ADDENDUM NO. 3

Re: **Batson Finishes 3rd Floor**
University of Mississippi Medical Center
Jackson, MS
IHL #209-585

EXHIBIT "A"

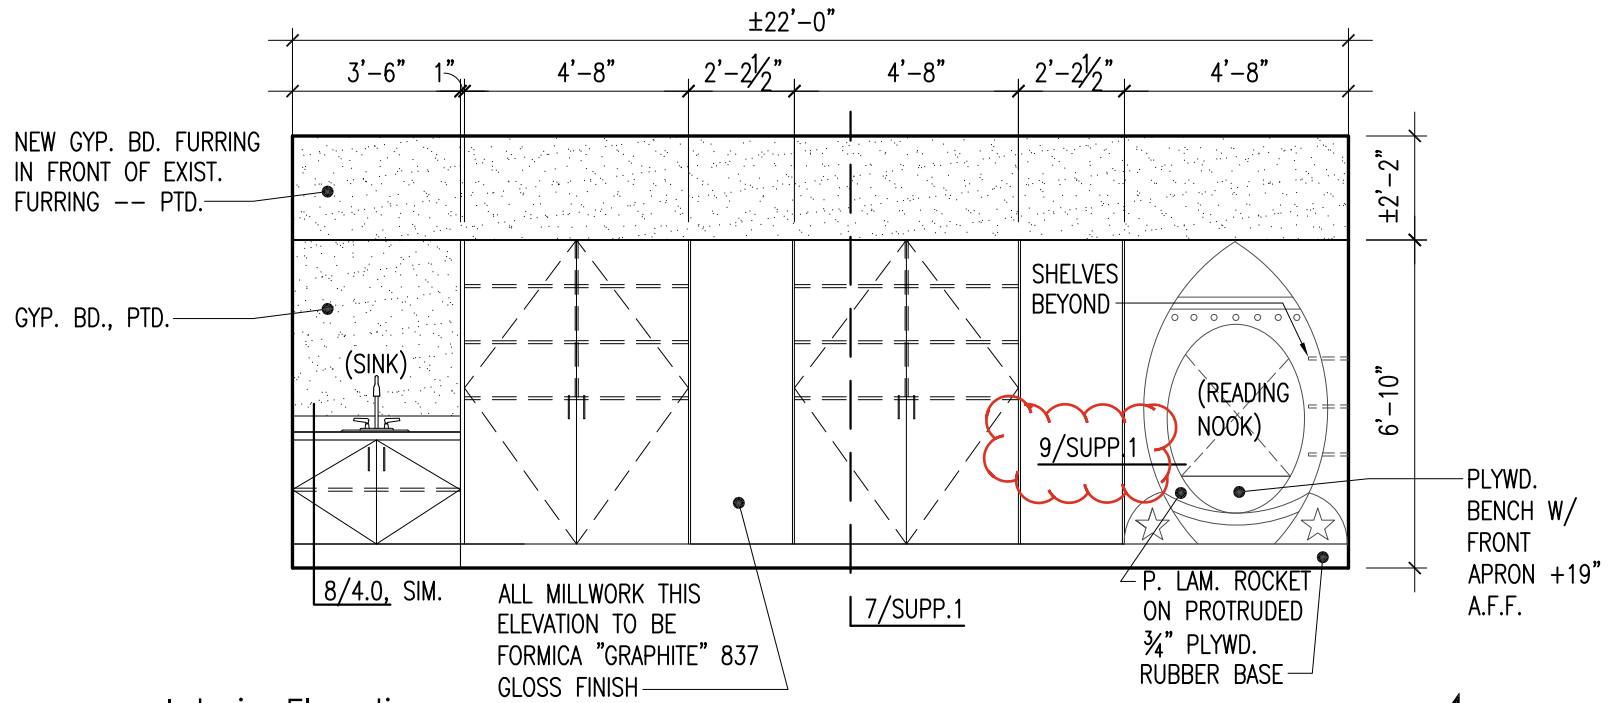
- Item No. 1: Refer to Sheet 1.0, Floor Plan, and note the following at room C370 (Safe Room):
Provide Sika EVERBUILD Technic Anti Pick 109 caulk, or equal, at all caulking applications this room (and adjacent toilet).
- Item No. 2: Refer to detail "4/Supp.1" (attached Exhibit "A") for location of detail "9/Supp.1".
